**EARLY DESIGN GUIDANCE  
of  
THE DOWNTOWN DESIGN REVIEW BOARD**

**31 July 2007**

Project Number: 3007182

Address: 1923 Fifth Avenue

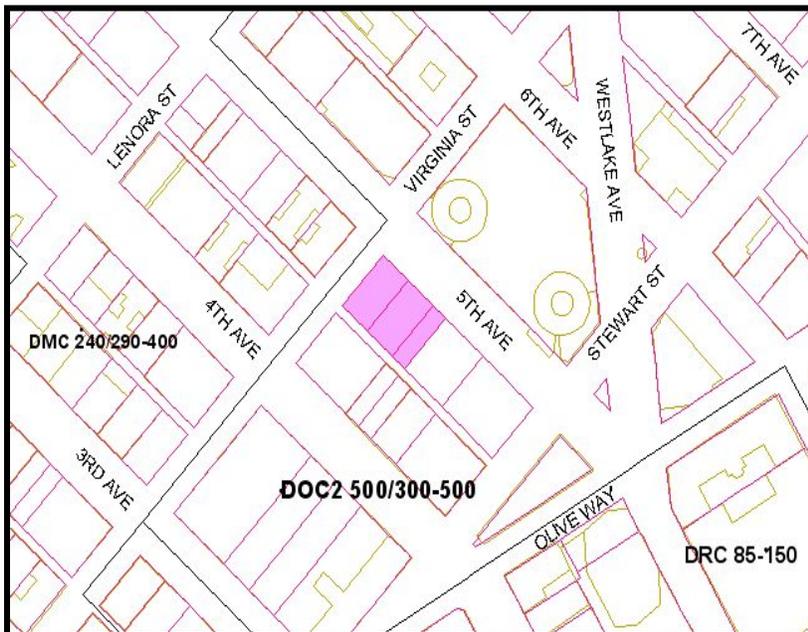
Scheme #3's site plan, which directs vehicular access to the alley, places retail uses along Virginia St. and activates the hotel lobby with a bar and lounge, met the Board's expectations. The other two schemes which depicted curb cuts on Virginia St. and Fifth Ave. did not receive Board support and did not meet Land Use Code requirements.

The Board expressed its disappointment with several aspects of the proposal as it relates to the present and future physical environment. Both the packet and the presentation lacked a compelling analysis of the built environment---an analysis that would inform the design and convince the Board that the base relates to the intricacies of the three downtown neighborhoods it would appear to join. This analysis remains the foundation of the EDG process. The presentation and packet also treated the Pagoda in a singular way as if the Heron was non-existent. The drawings of the base, for example, should have shown both towers with the Avis building in between them. Additionally, representation of the Escala was minimal in the drawings and did not suggest the impact or influence upon both the pedestrian experience and

The Board could not assume that twin towers were the most appropriate design response without evidence of much more analysis. There should be a series of studies or sketches depicting a variety of relationships between the towers. Early design analysis should show: varying heights, asymmetry, variations in potential materials and volumes or massing. The architect should then elaborate upon three or four distinct and viable versions to show their relationship on the skyline from all compass points, from the major streets, from major points of interest or view points. These versions should be placed in context with nearby towers (the Westin) and future towers (Escala) and others in the vicinity and represented in both drawings and model. The latter should be at a large scale and should include more city blocks than the model displayed at the EDG meeting. The various representations for the Pagoda and the Heron can be in chip board or styrofoam that they are easily built and manipulated.

Board members expressed their dismay that there no true alternatives massing schemes presented at the EDG meeting. Scheme #1 was missing from the packet. Scheme #2 was a modest variation of the preferred option.
